**ADDENDUM #2**

**TO CONTRACT DOCUMENTS FOR:** Project CP231262 – Schweitzer Hall Roof Replacement

**PREPARED FOR:** The Curators of the University of Missouri  
Planning, Design & Construction  
University of Missouri  
130 General Services Building  
(573) 882-6800

SHEET  
**A1.00**

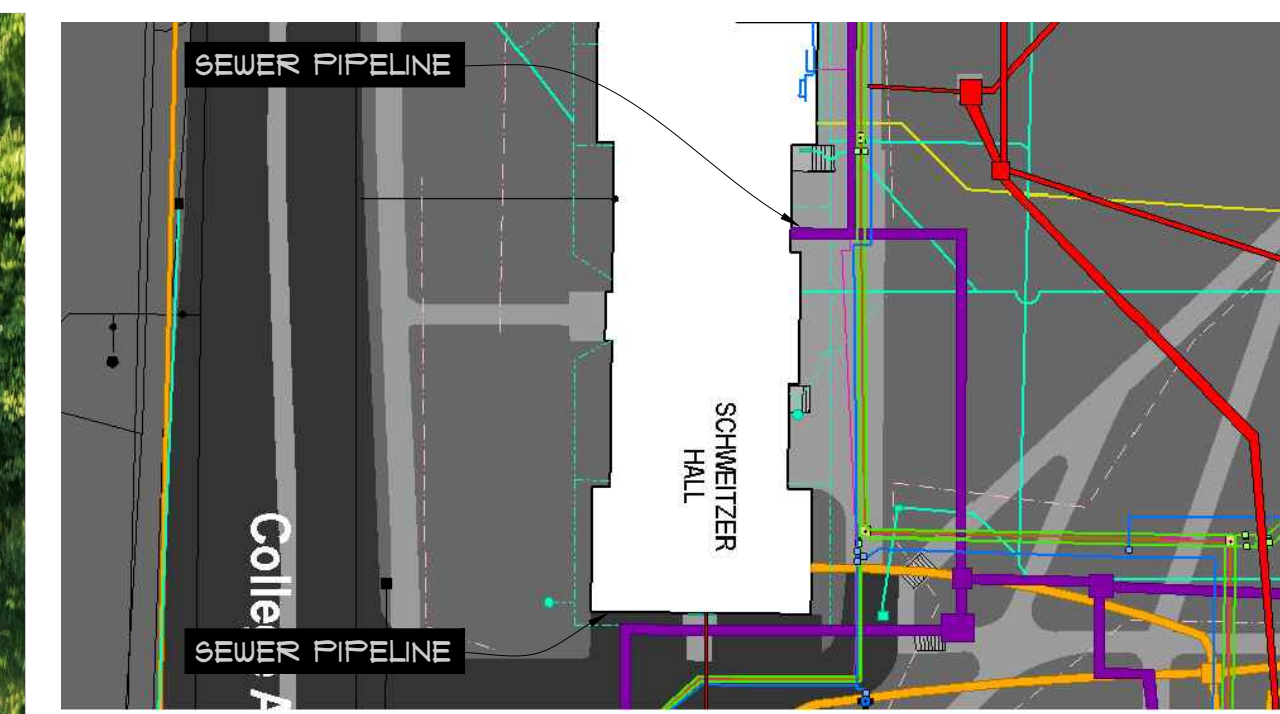
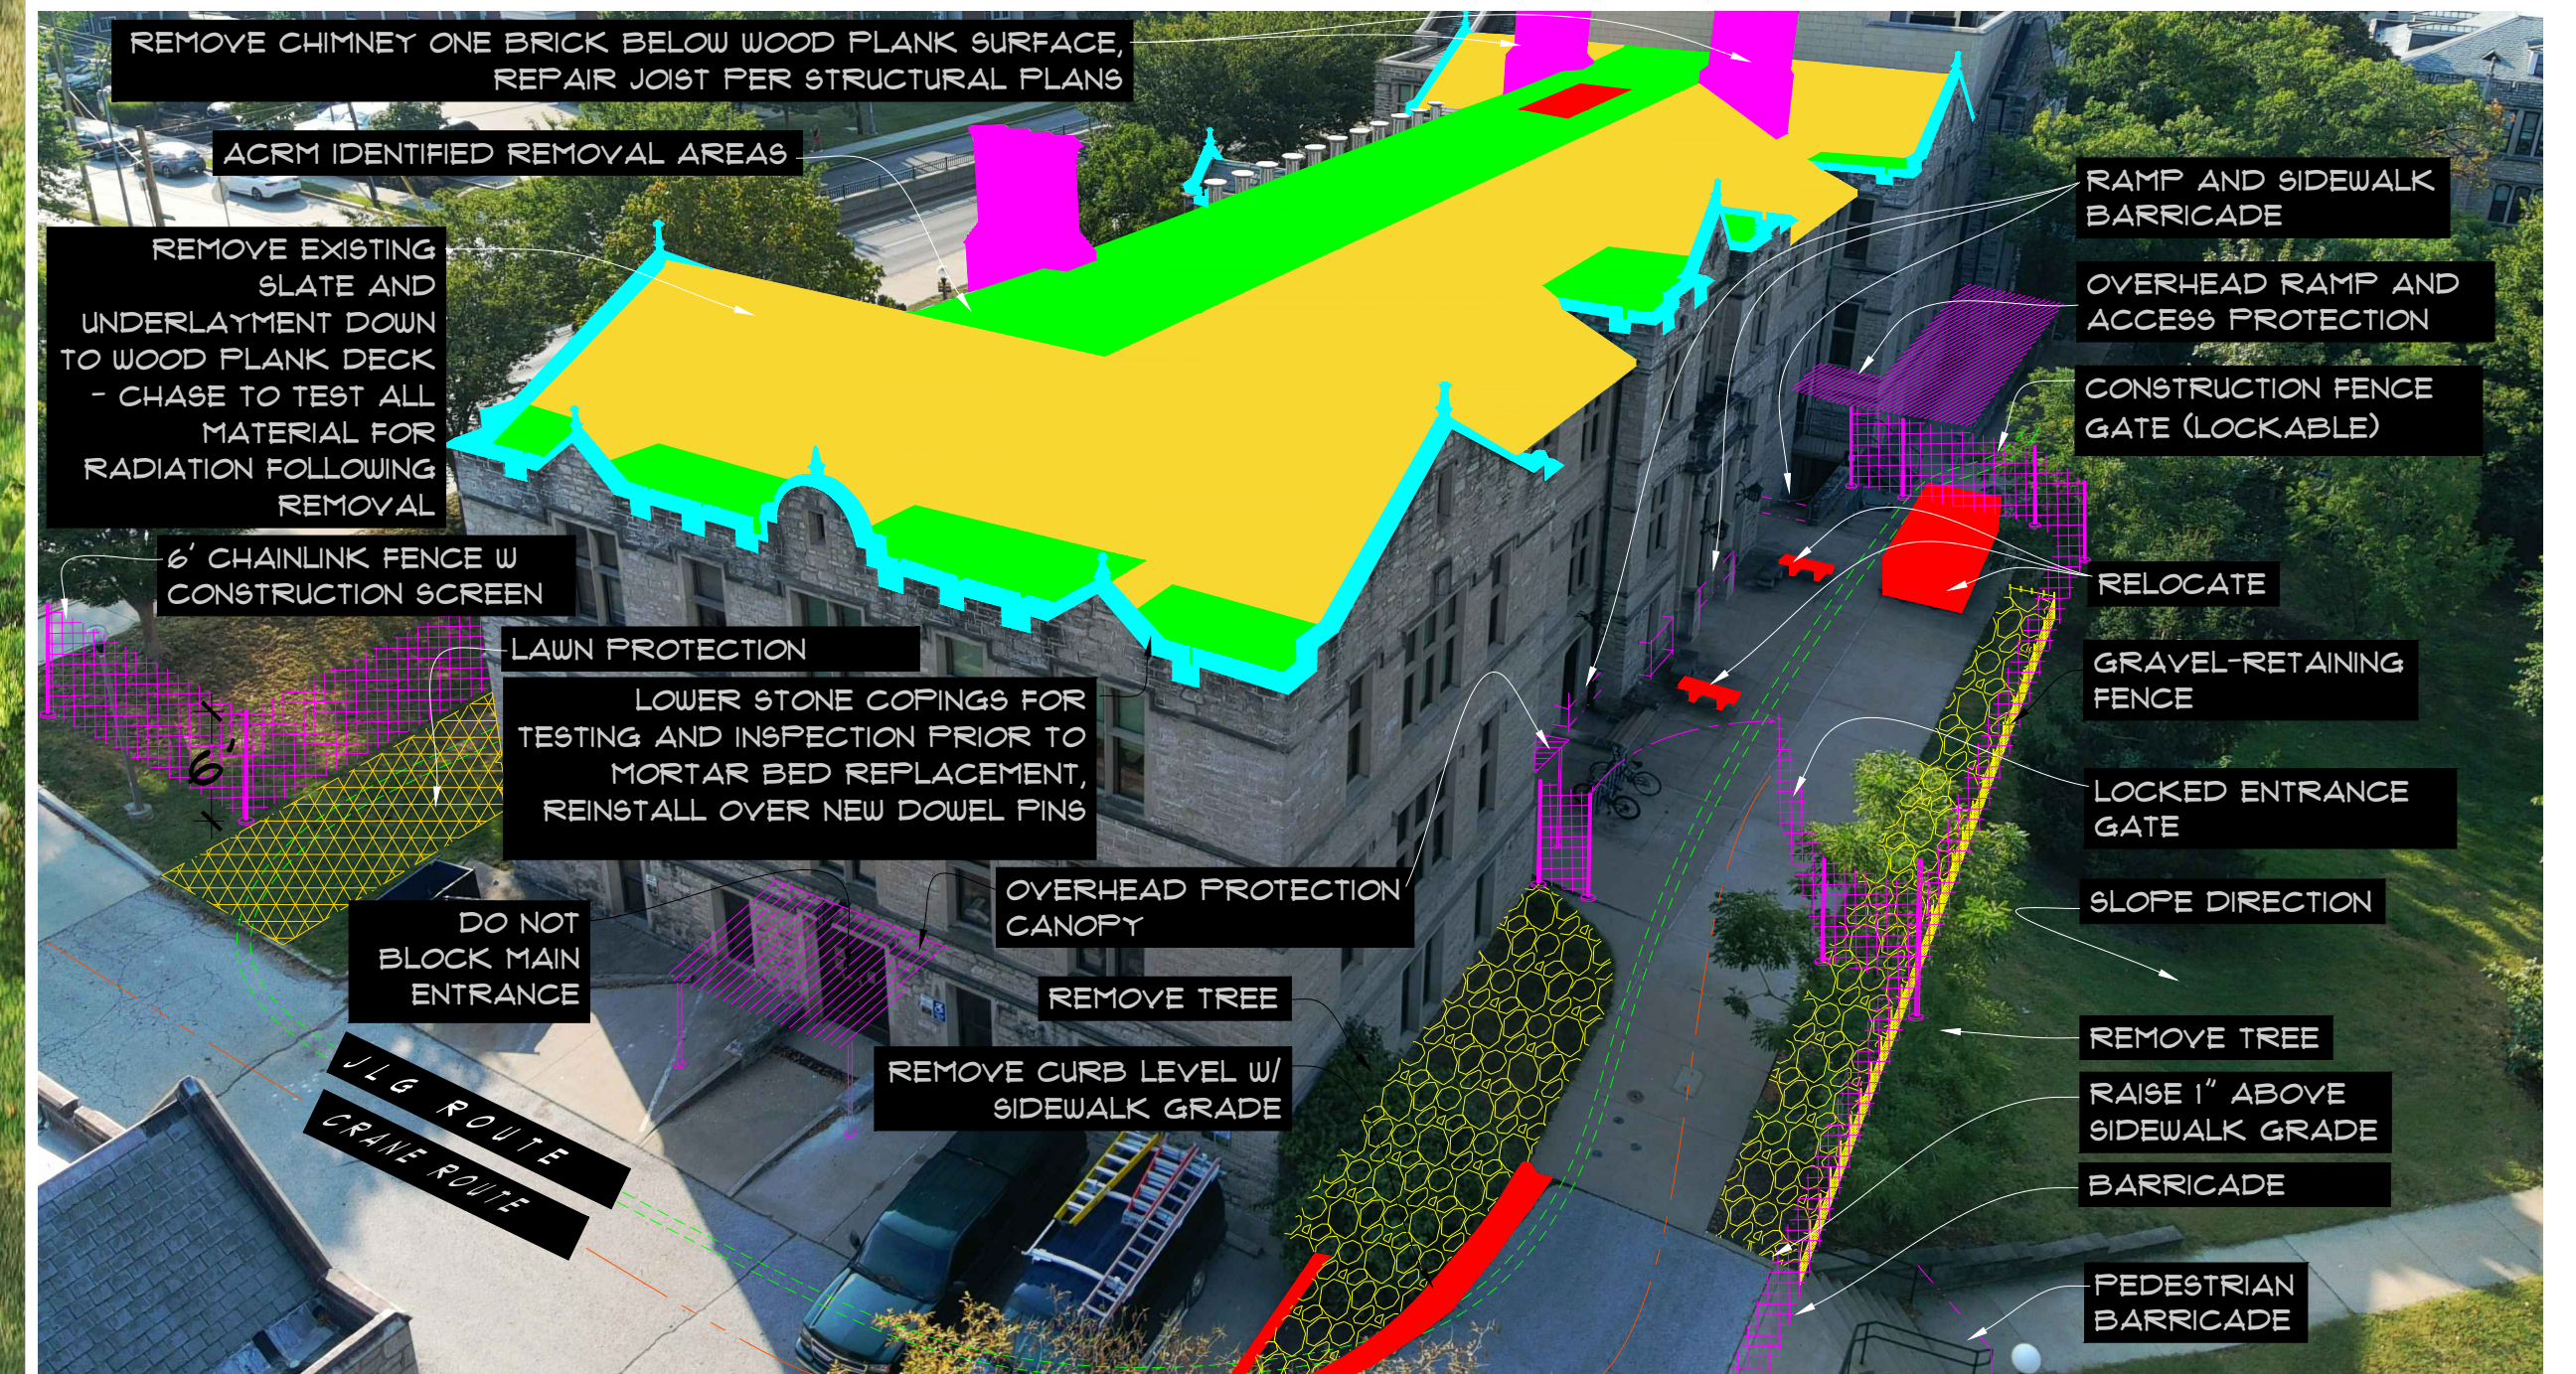
**CLARIFICATION** - Please refer to dwg A 1.00 General Quantities ACRM  
ROOFING REMOVAL= 3,000 SQ FT

- 1) A1.00 – **REVISED** – See responsibility of Scope of Work
